Procurement #: 54502

RFP Title: :Bundled School Construction Classical High School Commercial Chiller and Reservoir & Leviton Elementary Schools RTU Replacements

Addendum #: 1

RFI Questions and Response

Classical HS Bundled Chiller Replacement Project

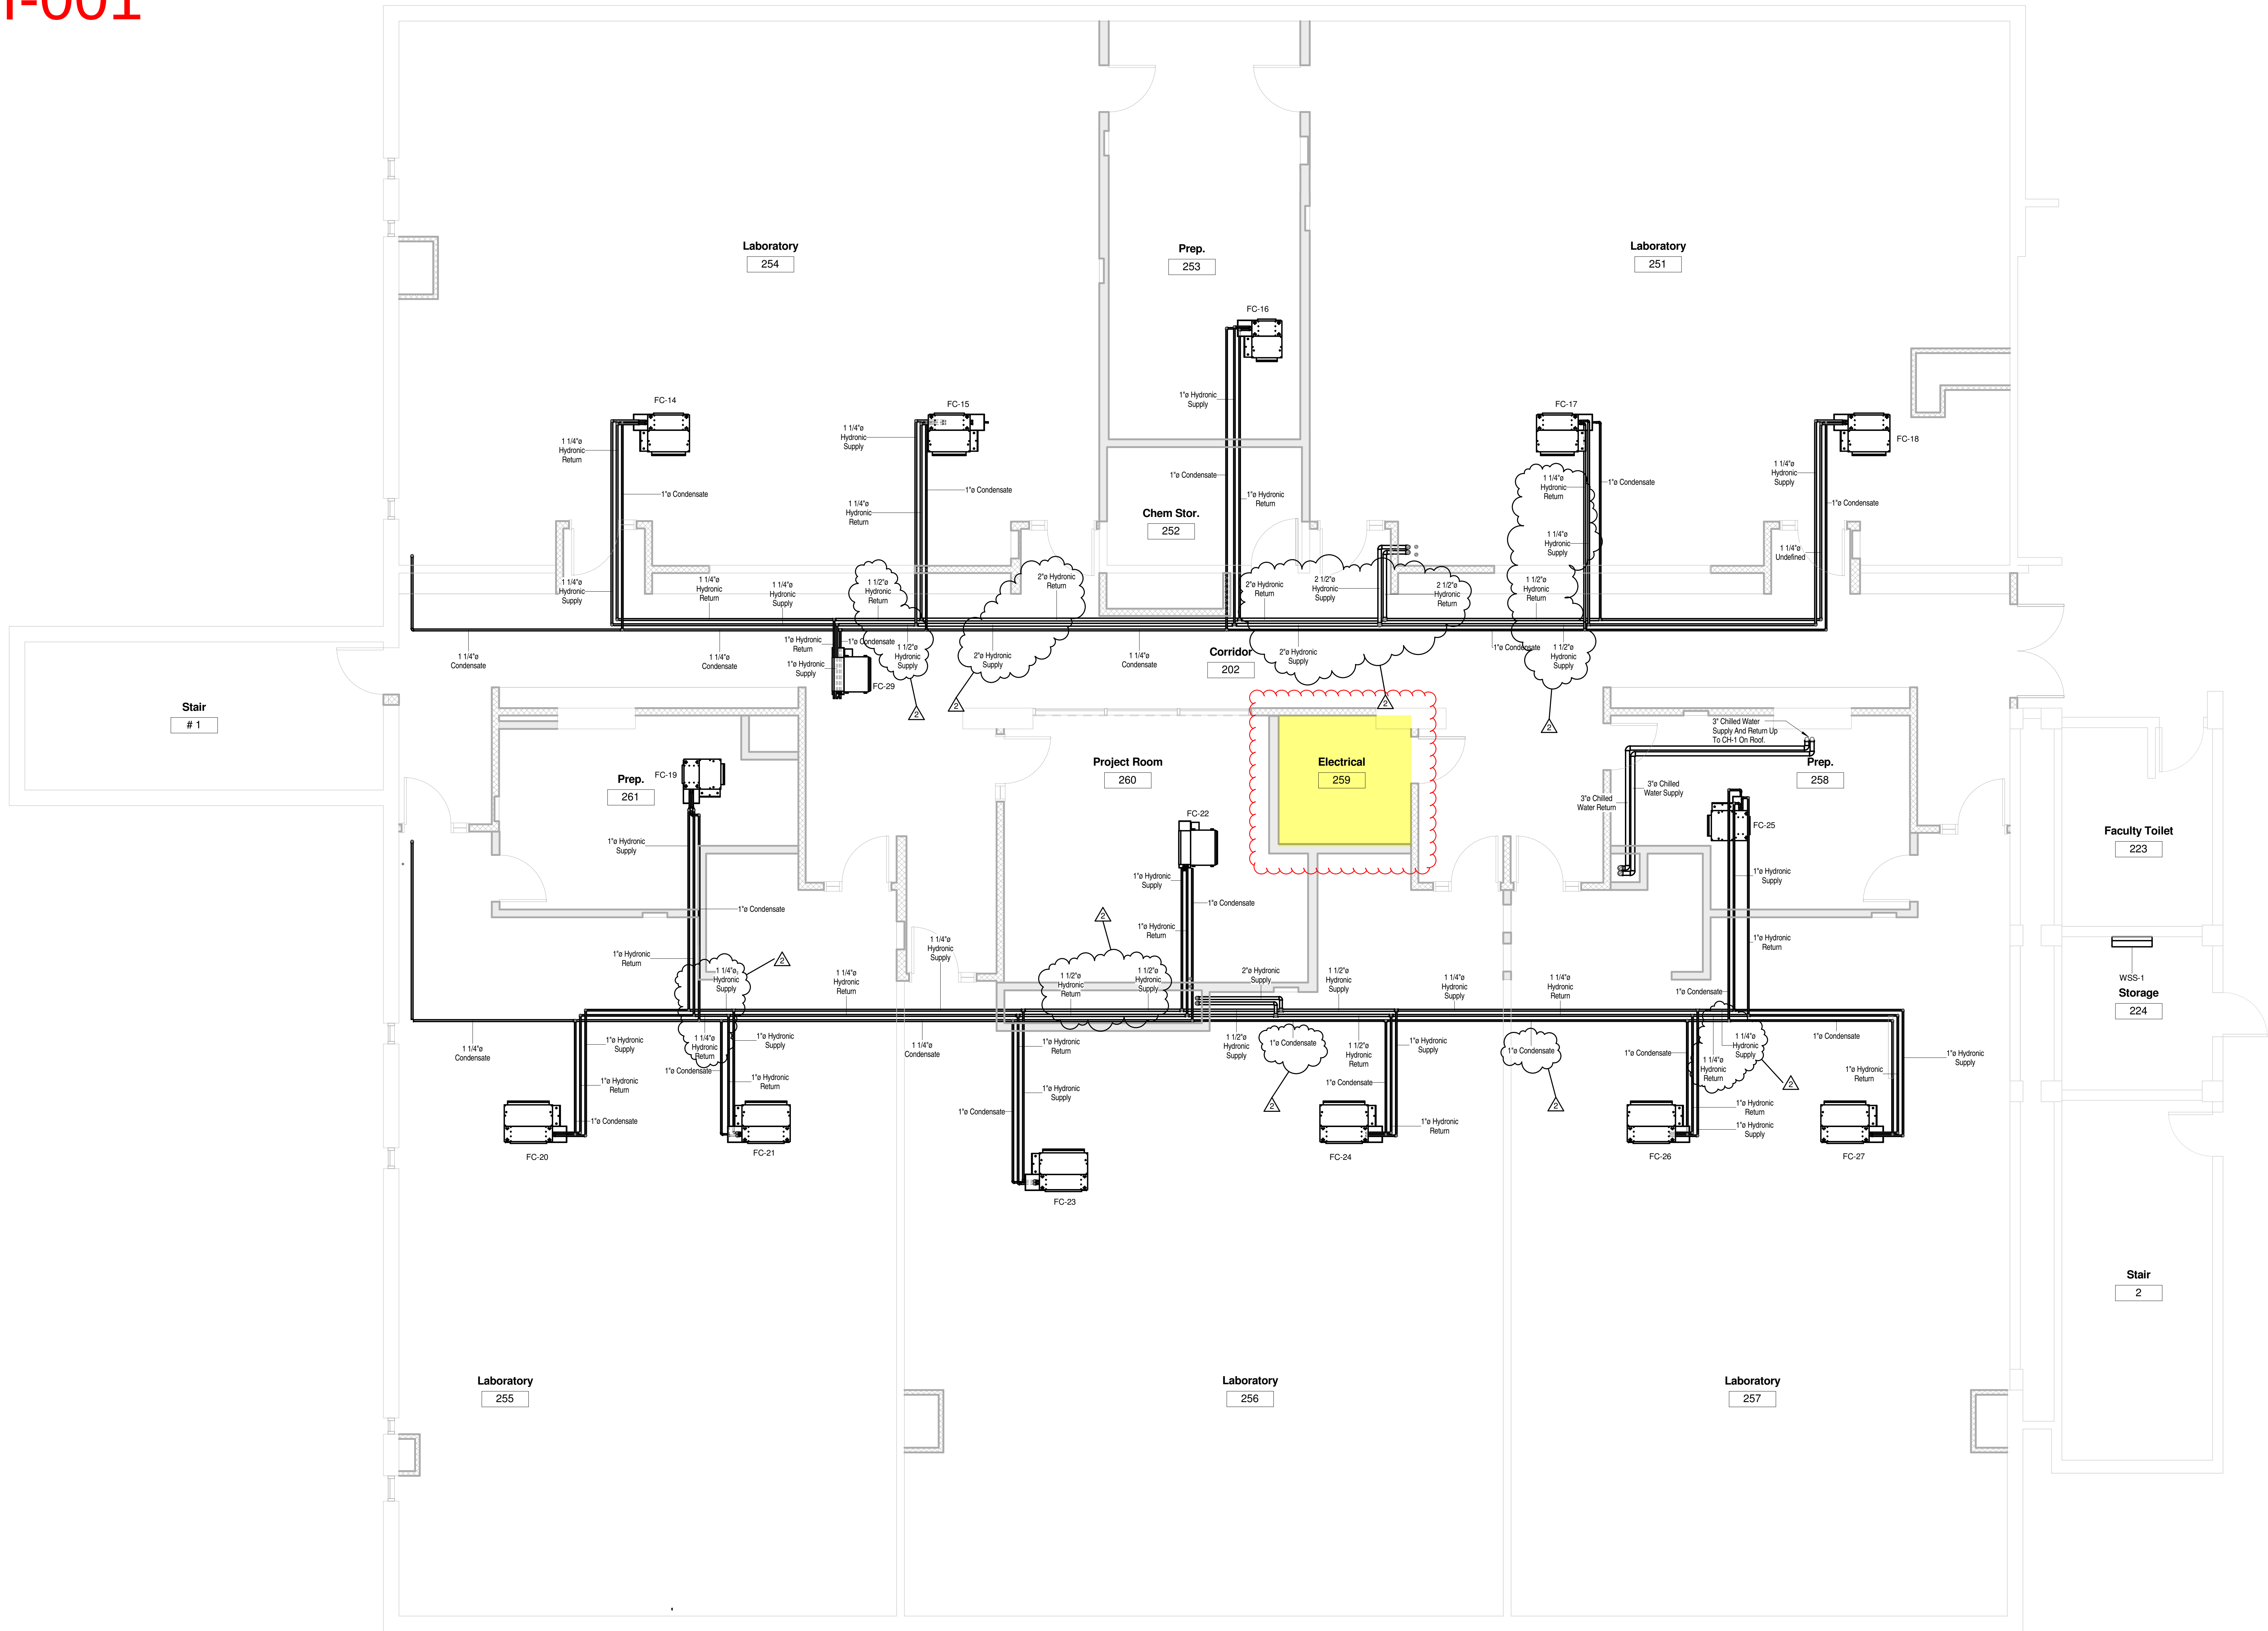
RFI No.	Priority	Site / Discipline	Document / Drawing Reference	Description of Discrepancy or Missing Information	RFI Question	RFI Response
RFI-001		Classical HS	ME1.2	Room 259 is not included on the drawings	Can you provide drawings of the building that indicate where RM 259 is located in relation to the replacement chiller for the purpose of accurately assessing the configuration and length of the new GFCI circuit.	SEE ATTCHED RFI-001 EXISTING FLOOR PLANS FOR REFERENCE. RM 259 and the chiller are highlighted in yellow and clouded in red.
RFI-002		Leviton Dual Language	ME2.2	Main Electrical Room is not included on the drawings.	Can you provide drawings of the building that indicate where main electrical room is located in relation to the replacement chiller for the purpose of accurately assessing the configuration and length of the new 80A and 200A circuits?	SEE ATTCHED RFI-002 EXISTING FLOOR PLANS FOR REFERENCE. Electric rooms are highlighted in yellow and clouded in red.

1 SECOND FLOOR HYDRONIC PLAN
8.5 1/4" = 1'-0"

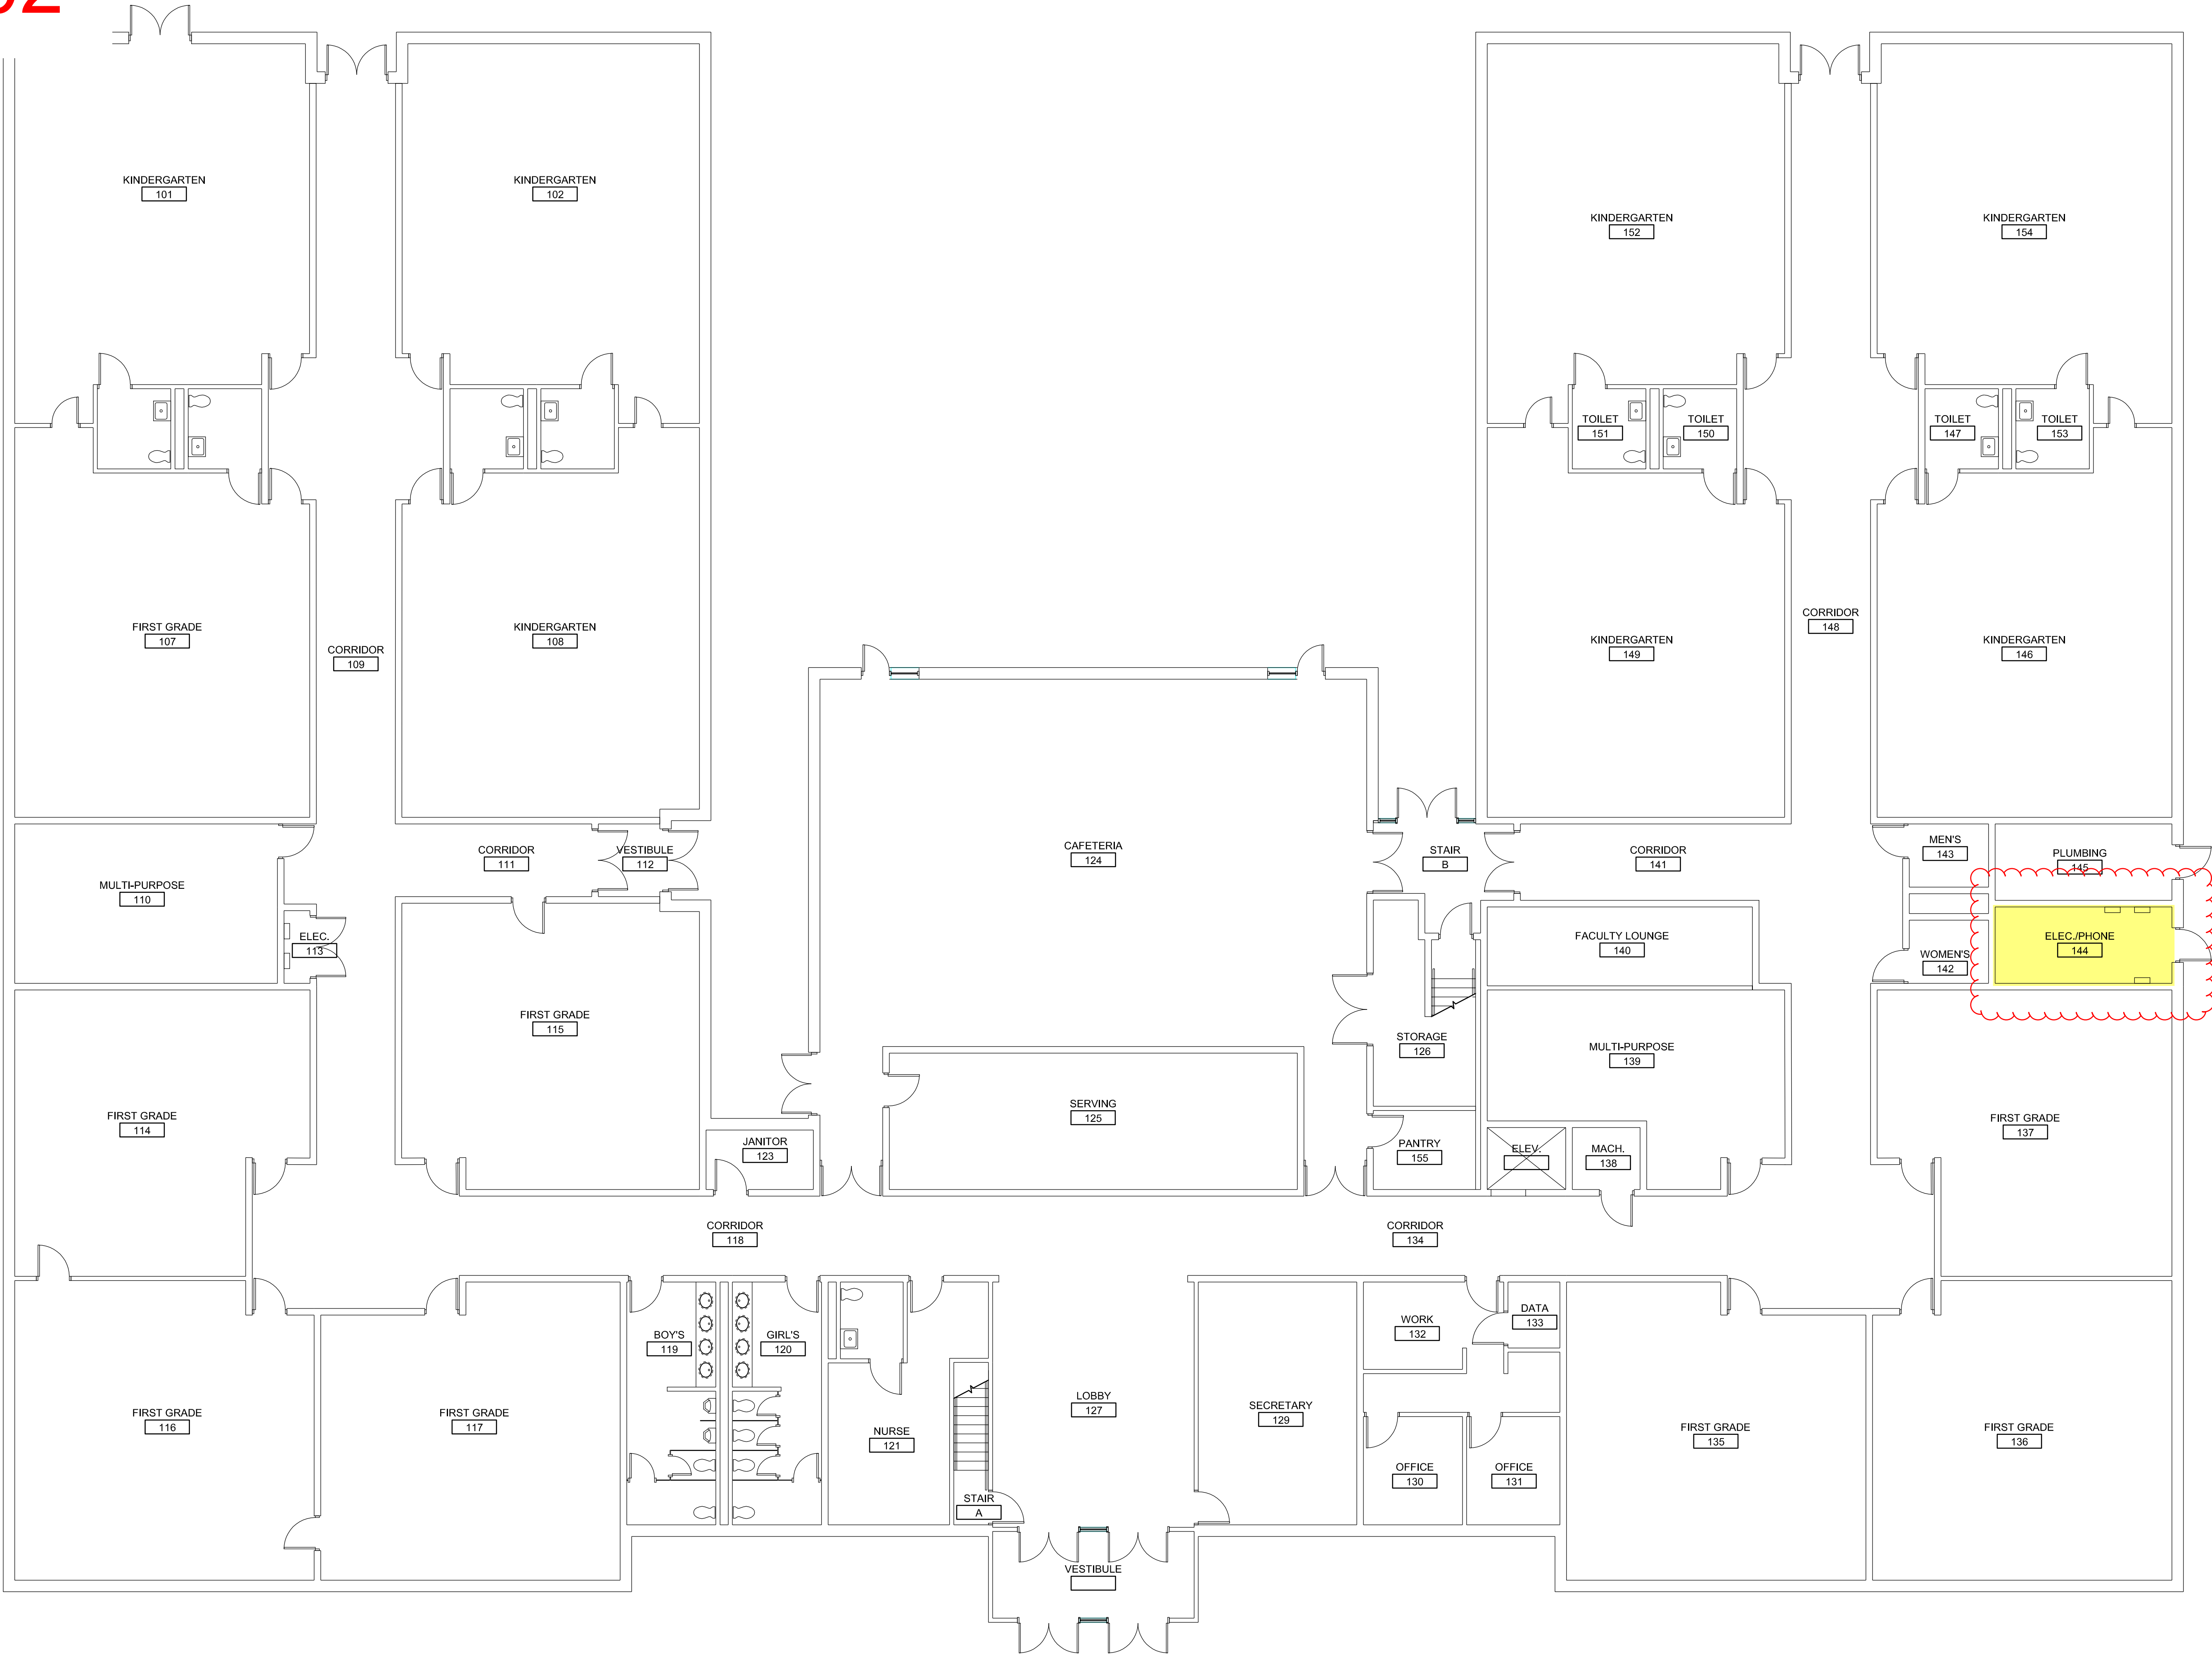
Classical HS Bundled Chiller Replacement Project						
RFI No.	Priority	Site / Discipline	Document / Drawing Reference	Description of Discrepancy or Missing Information	RFI Question	RFI Response
RFI-001		Classical HS	ME1.2	Room 259 is not included on the drawings	Can you provide drawings of the building that indicate where RM 259 is located in relation to the replacement chiller for the purpose of accurately assessing the configuration and length of the new GFCI circuit.	SEE ATTCHED RFI-001 EXISTING FLOOR PLANS FOR REFERENCE. RM 259 and the chiller are highlighted in yellow and clouded in red.
RFI-002		Leviton Dual Language	ME2.2	Main Electrical Room is not included on the drawings.	Can you provide drawings of the building that indicate where main electrical room is located in relation to the replacement chiller for the purpose of accurately assessing the configuration and length of the new 80A and 200A circuits?	SEE ATTCHED RFI-002 EXISTING FLOOR PLANS FOR REFERENCE. Electric rooms are highlighted in yellow and clouded in red.
